**Grid Code  
Modification  
Recommendation Form**

Correction of Connection Voltage Graphs for 110kV and 220KV Systems under PPM1.6.3.4

**MPID:** MPID 279

**Grid Code Section(s) Impacted by  
Recommended Proposal:** PPM1.6.3.4

**110kV Connection Voltage**

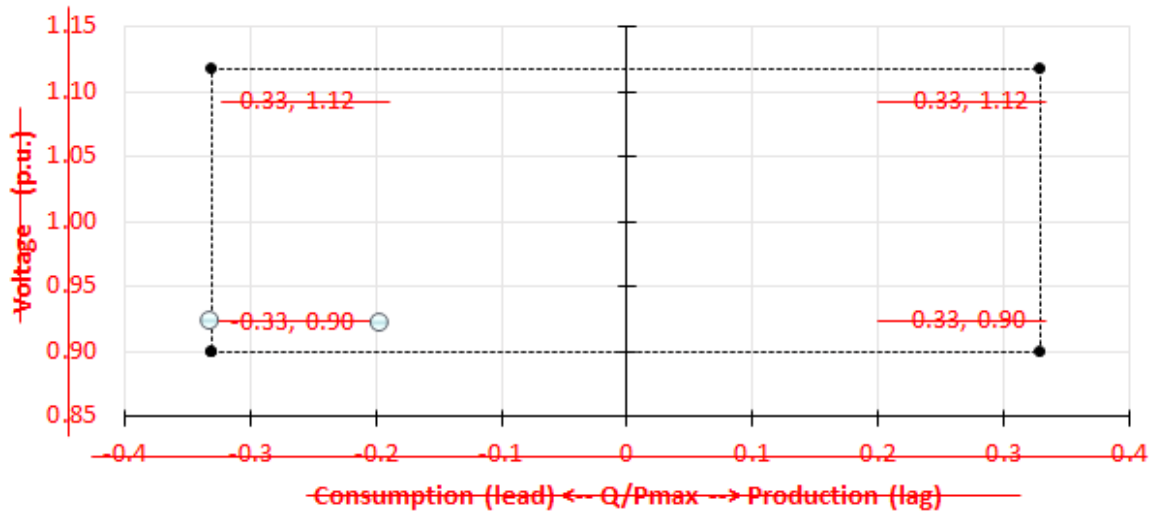
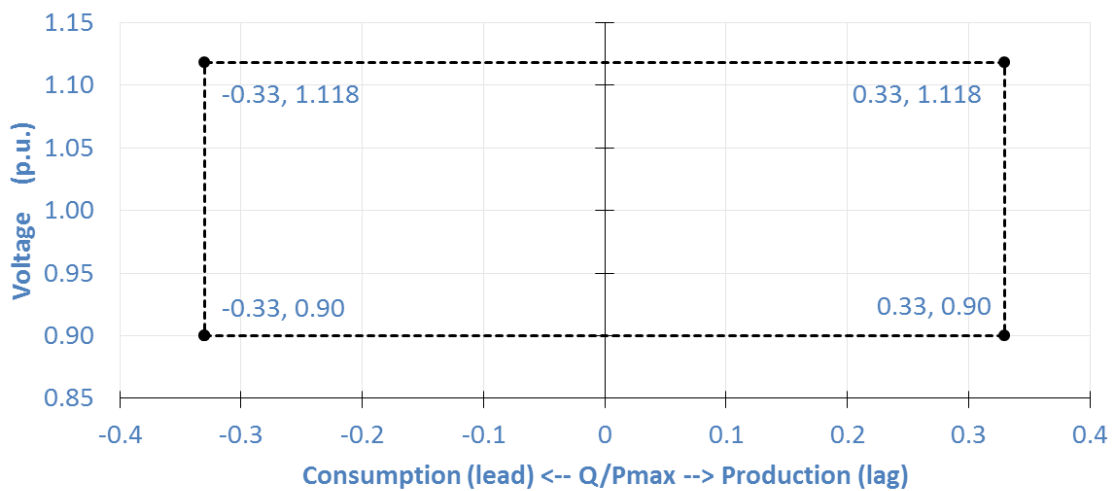
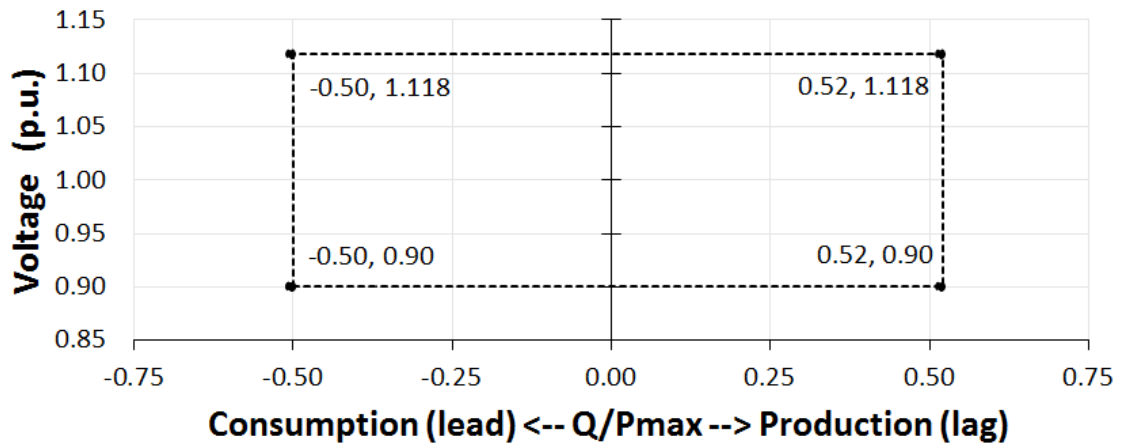
PPM1.6.3.4 shows a maximum voltage withstand capability of 1.12p.u. for connections at 110 kV and 220 kV. In the case of 110kV and 220 kV, this would require equipment to have the capability to continually withstand 123.2kV and 246.4 kV respectively.

As per clause CC.8.3.2, the maximum transmission system voltages during a transmission fault for 110kV and 220kV are nominally 123kV and 245kV respectively. This equates to an upper voltage limit of 1.118p.u. for 110kV transmission systems and 1.114p.u. for 220kV transmission systems. The values in clause PPM1.6.3.4 should be aligned with the values stated in clause CC.8.3.2.

To rectify this Grid Code inconsistency, we propose separating out the graphs for 110kV and 220kV and correcting the upper voltage limits within them to state 1.118p.u. for 110kV systems and 1.114p.u. for 220kV systems.
